Kingscourt Town Centre
Regeneration Scheme

Stage 1 Road Safety Audit

Document Ref: P22-187-SA01-RP-001

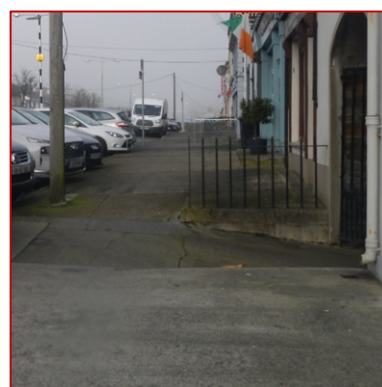
3.2 Problem

Location: At various locations Throughout the Scheme

Summary: Possible slips, trips or falls at height hazards within the scheme.

The existing footpaths include a number of changes in level, with some locations including steps & steep gradients most of which are protected by railings.

The proposed scheme will, presumably, remove many of these existing level differences, however, some will remain. For example a level difference has been indicated as being retained between the footpath and the adjacent parking spaces, to be separated by steps, along the section of the western side Main Street immediately south of its junction with Rocks Road and the vicinity of the northbound bus stop to the north of the Rocks Road junction.

It is unclear from the information provided what, if any, measures would be provided to advise visually-impaired or inattentive pedestrians of the remaining height hazards.

Measures should be provided (e.g. railings, tactile paving) to warn visually-impaired or inattentive pedestrians of the height hazards within the Scheme (for example: the steps on the western side of Main Street immediately south of its junction with Rocks Road). Gradients within the pedestrian areas should comply with the guidance published by the National Disability Authority.

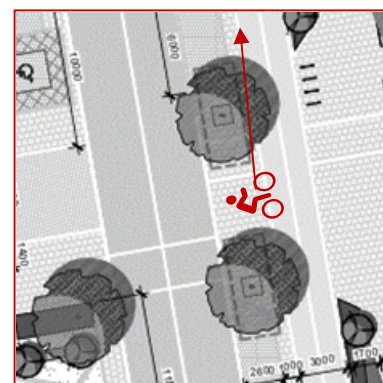
3.4 Problem

Location: Drawing 221545-1-101 (-)

Summary: *Overhanging trees may present hazards to pedestrians and cyclists travelling on the proposed Non-Motorised Users (NMUs) facilities.*

Trees have been indicated within the proposed scheme which overhang the proposed footpath areas & the proposed cycle facility. It is unclear what the clear-height to the canopy of the proposed trees would be.

If the canopies have insufficient vertical clearance there is a risk that the branches of trees may present a hazard to pedestrians, particularly the visually impaired, and cyclists resulting in road users colliding with low-hanging branches and suffering personal injuries.

In addition, as the trees shed leaves in the autumn/winter months these may accumulate within the NMUs facilities where they may pose a slip/skid risk to pedestrians and cyclists using the facilities.

Adequate vertical clearance to tree canopies should be provided. Routine maintenance should be undertaken to ensure that excessive accumulation of leaves does not occur on the pedestrian and cyclist facilities.

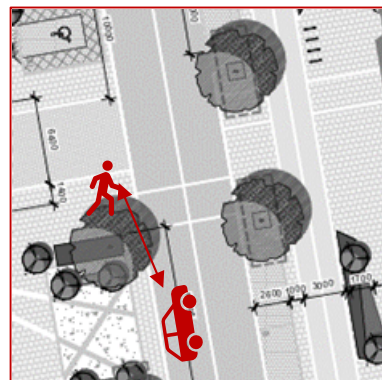
3.5 Problem

Location: Drawing 221545-1-101 (-)

Summary: *Proposed planting may impede inter-visibility between pedestrians and drivers at several crossing locations throughout the scheme.*

Trees have been indicated adjacent to the proposed crossings within the scheme. It is unclear from the information provided what type/species of tree/planting is proposed at these locations.

Planting/trees could impede inter-visibility between pedestrians and drivers at crossings which could lead to drivers failing to see a pedestrian about to undertake the crossing, resulting in a failure to stop and possible vehicular/pedestrian collisions

Planting/trees adjacent crossings should not restrict inter-visibility between pedestrians intending to use the crossing and drivers on the approach to the crossing.

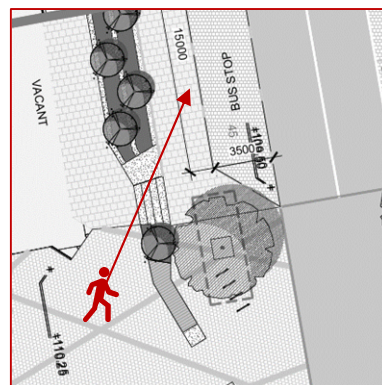
3.6 Problem

Location: Drawing 221545-1-101 (-)

Summary: *Loading/unloading activities at the proposed loading bay could result in personnel standing within the carriageway.*

The proposed Loading Bay on the access to the new car park from Main Street is bounded by a grassed verge area.

This is likely to result in loading activities occurring to/from the adjacent carriageway, with a resulting increased risk of goods or operatives being struck by passing vehicles.

An area off of the carriageway should be provided adjacent to the proposed Loading Bay where loading/unloading activities can be undertaken safely.

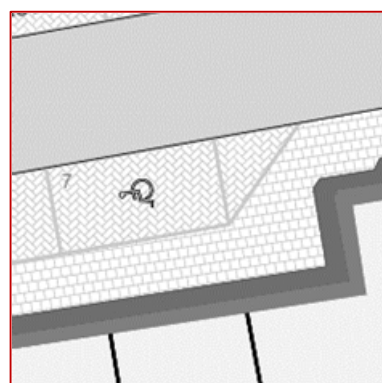
3.11 Problem

Location: Drawing 221545-1-101 (-)

Summary: Drivers may be unaware of the one-way system within the car park, and unintentionally travel against the flow of traffic, leading to low-speed head-on collisions.

The proposed carpark layout includes one-way sections. At this early stage in the design process traffic signage and road markings have not been indicated. Should drivers be insufficiently aware of the one-way flow they could unintentionally travel against the flow of traffic, leading to low-speed head-on collisions.

During the design development appropriate signs and road markings should be provided indicating the one-way section of the car park.

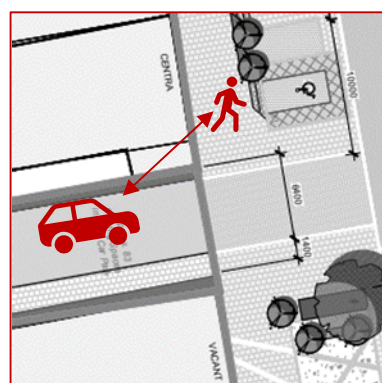
3.12 Problem

Location: Drawing 221545-1-101 (-)

Summary: The effective width of the footpath adjacent the mobility-impaired parking space within the carpark may be insufficient for the mobility-impaired, particularly wheelchair users.

The footpath adjacent the mobility-impaired parking space alongside the south-eastern footpath on the carpark access road appears to be narrow.

It is unclear if the effective width of the path will be sufficient to accommodate the mobility-impaired, particularly wheelchair users. This could result in these road users choosing to travel within the carriageway, where there is an increased risk of being struck by a vehicle.

The effective width of the footpaths within the scheme should be sufficient to accommodate all non-motorised road users.

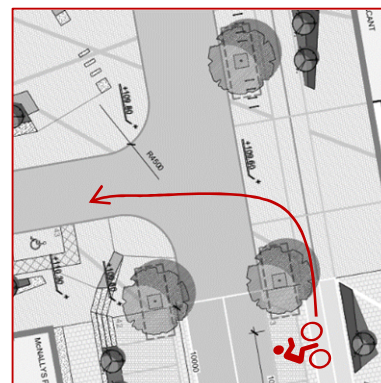
3.13 Problem

Location: Drawing 221545-1-101 (-)

Summary: The building boundary at the car park access may reduce inter-visibility between pedestrians about commence crossing and drivers exiting from the carpark onto the Main Street.

The existing building boundary either side of the car park access at its junction with Main Street may impede inter-visibility between exiting drivers and pedestrians about to commence a crossing, increasing the risk of vehicle/pedestrian.

Adequate inter-visibility should be provided between drivers exiting the carpark and pedestrians about commence a crossing at this location.

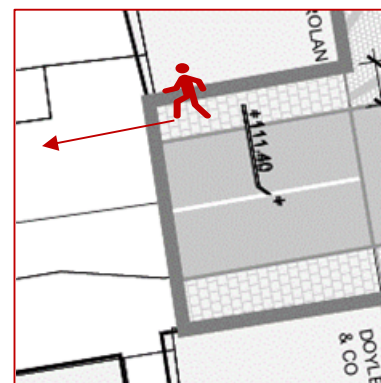
3.14 Problem

Location: Drawing 221545-1-101 (-)

Summary: It is unclear how cyclists on the proposed cycle track can safely turn onto Rocks Road, and vice versa.

A cycle track is proposed along the eastern side of Main Street. It is unclear how it is intended that cyclists can turn left from the cycle track onto Rocks Road, and vice versa.

Should a lowered kerb arrangement not be provided this may lead to cyclists attempting to traverse a full-height kerb when turning resulting in possible falls and personal injuries.

Measures should be provided which allow cyclists turn from the cycle track onto Rocks Road, and vice versa.

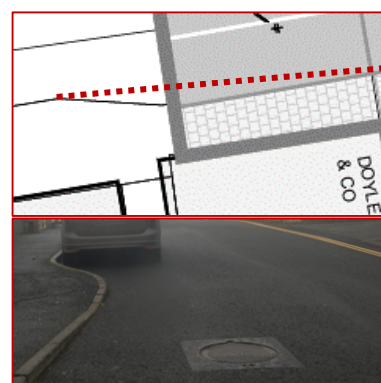
3.15 Problem

Location: Drawing 221545-1-101 (-)

Summary: Discontinuity in existing footpath along northern side of Rocks Road to the west of the Scheme.

There is a discontinuity in the footpath on the northern side of Rocks Road, west of Market Square. A footpath is shown extending along Market Square to the northern side of Rocks Road. Pedestrians on the Market Square heading west on this side of the road could continue within the carriageway with a resulting increased risk of being struck.

Either a continuous footpath should be provided along the northern side of Market Square and the footpath on the northern side of Rocks Road, or measures should be provided which direct both eastbound and westbound pedestrians on the northern side of the road to the continuous footpath along the southern side of Rocks Road, including appropriate crossing facilities where required.

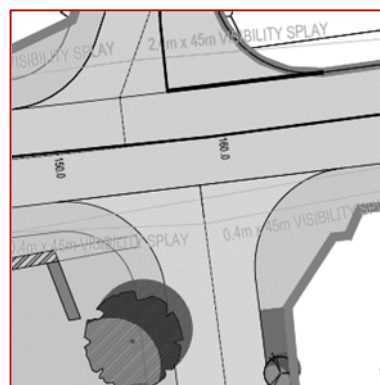
3.16 Problem

Location: Drawing 221545-1-101 (-)

Summary: The existing alignment of the kerb on the southern side of Rocks Road changes relatively abruptly immediately west of Market Square, which may lead to wheel strikes or avoidance manoeuvres.

The existing alignment of the kerb on the southern side of Rocks Road changes relatively abruptly immediately west of Market Square, which may lead to wheel strikes or avoidance manoeuvres.

Drivers often use the kerb as a guide when travelling along a carriageway, and abrupt changes in direction, or sharp deflections, may result in drivers unfamiliar with the road striking the kerb, resulting in material damage collisions, or to sudden avoidance manoeuvres.

The kerb along the southern side of Rocks Road within Market Square should transition smoothly to the existing kerb build-out.

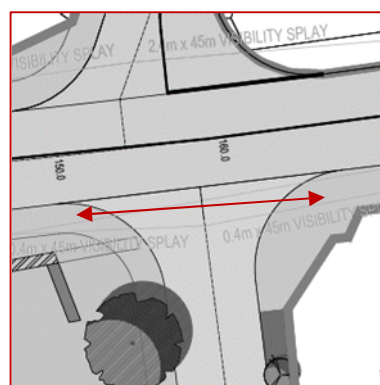
3.18 Problem

Location: Drawing 221545-1-102 (-)

Summary: No pedestrian crossing has been indicated across the proposed entrance to the carpark from Rocks Road.

No pedestrian crossing has been indicated across the proposed access to the proposed carpark from Rocks Road. This could result in mobility impaired pedestrians being unable to safely navigate this section of the road layout.

Prioritise pedestrian movements across the carpark access by providing a continuous footpath.

Alternatively, a pedestrian crossing, including dropped kerbs and tactile paving, should be provided at the carpark access.

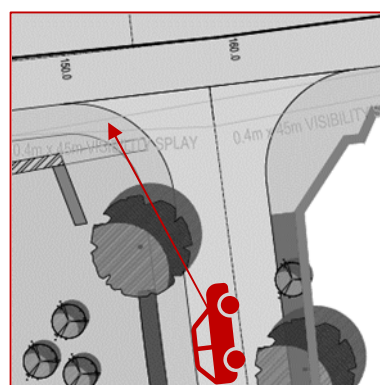
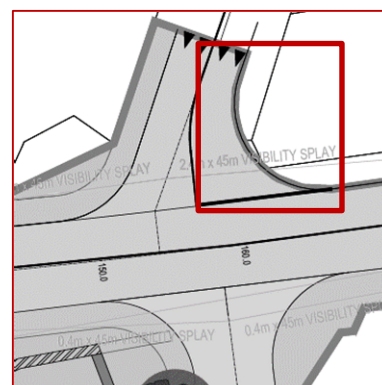
3.19 Problem

Location: Drawing 221545-1-102 (-)

Summary: Drivers exiting the carpark onto Rocks Road may have restricted visibility towards a potential sign indicating priority.

The proposed tree on the western side of the access road on the immediate approach to its junction with the Rocks Road may impede visibility towards a junction regulatory sign.

This may result in approaching drivers being insufficiently aware of the need to stop or yield, leading to overshoot into the footpath, resulting in an increased risk of vehicle/pedestrian collision.

The tree should be relocated to where it wouldn't impede visible towards junction signs for drivers exiting the car park.

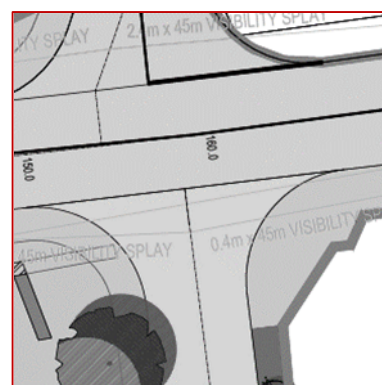
3.20 Problem

Location: Drawing 221545-1-102 (-)

Summary: Discontinuous pedestrian facilities at north-eastern corner of the Rocks Road/Bóthar Mhuire Junction.

The Rocks Road/Bóthar Mhuire junction layout is proposed to be amended as part of the scheme. However, the proposed layout does not indicate retaining the existing footpath within the north-eastern corner. Should the footpath not be retained at this location pedestrians could choose to travel within the carriageway where there is a risk of being struck by a vehicle.

A footpath should be provided in the north-eastern corner of the junction between Rocks Road and Bóthar Mhuire.

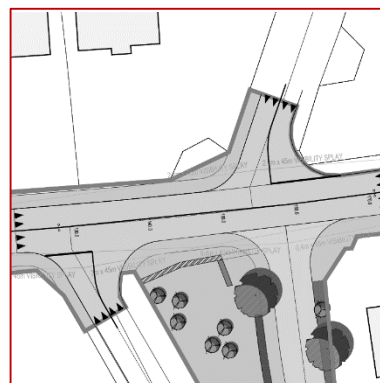
3.22 Problem

Location: Drawing 221545-1-102 (-)

Summary: Difference in levels at the proposed raised table have not been indicated.

The proposed works on the junction between Rocks Road and Bóthar Mhuire include a raised table.

It is unclear if there will be a level difference between the proposed raised-table and the adjacent footpaths.

The absence of level difference could result in visually-impaired pedestrians inadvertently entering the carriageway.

A minimum upstand of 60mm should be provided between the footpaths and the raised table.

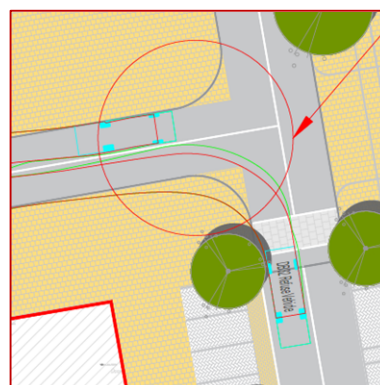
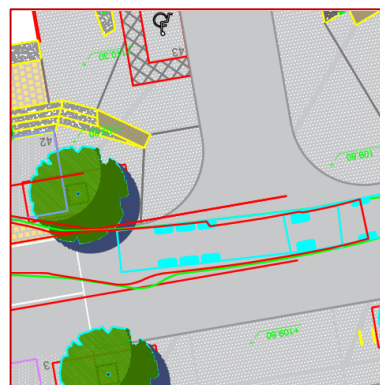
3.23 Problem

Location: Drawing 'Market Square Tracking'

Summary: Insufficient turning radii for vehicles at the junction between Main Street and Rocks Road.

The proposed realignment of the Rocks Road, and the corner radii at its junction with Main Street, may result in road layout that is not capable of accommodating the swept path of all vehicles likely to use the road & junction.

This could lead to vehicles overrunning the footpaths as they turn/traverse this area, presenting a potential hazard to NMUs within the footpath/pedestrian areas.

Sufficient turning radii should be provided to support safe turning movements at the junction between Main Street and Rocks Road.

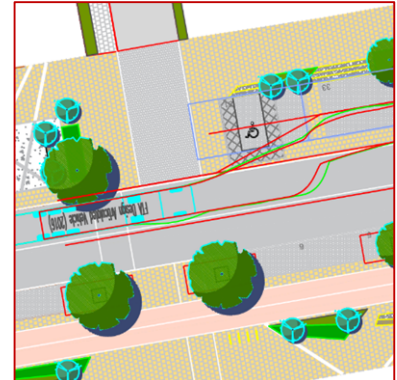
3.25 Problem

Location: Drawing 'Main Street Loading Bay Tracking'

Summary: Potential for large vehicles to collide with vehicles parked at the mobility impaired parking space adjacent the loading bay.

The swept path analysis drawings suggest evidence of large vehicles overhang conflicting with the mobility impaired parking space adjacent the loading bay which might lead to material damage.

The parking spaces and loading bay should have mutually exclusive time restrictions to avoid the potential for conflicts between parked vehicles and vehicles using the loading bay.
